March 17, 2015

15-BSTD-01

Proposed Revisions to the California Building Energy Efficiency Standards California Code of Regulations, Title 24, Part 6 and Appendices; 45-Day Language

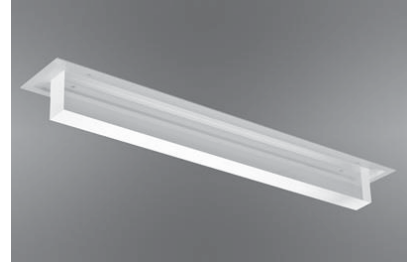
- vi. Lumen Maintenance and Rated Life – As mentioned previously, the Energy Star test method referenced for the Ambient Temperature Life test is not appropriate or applicable to luminaires with integrated SSL sources. Additionally, historically Lumen Maintenance and Rated Life testing for luminaires has been evaluated at the source level using IES LM-80 data, IES TM-21 projections and in situ temperature measurements in the luminaire, not testing a complete luminaire for 6000 hours. The requirement of testing complete luminaires for 6000-hours will create a significant cost burden on luminaire manufacturers, since luminaires are not testing to the referenced Energy Star test method.

We recommend that the CEC include an option of evaluating lumen maintenance and rated life of luminaires with integrated SSL sources using IES LM-80 data, IES TM-21 projections and in situ temperature data. We also request that CEC provide the technical and cost justification for applying this requirement to luminaires.
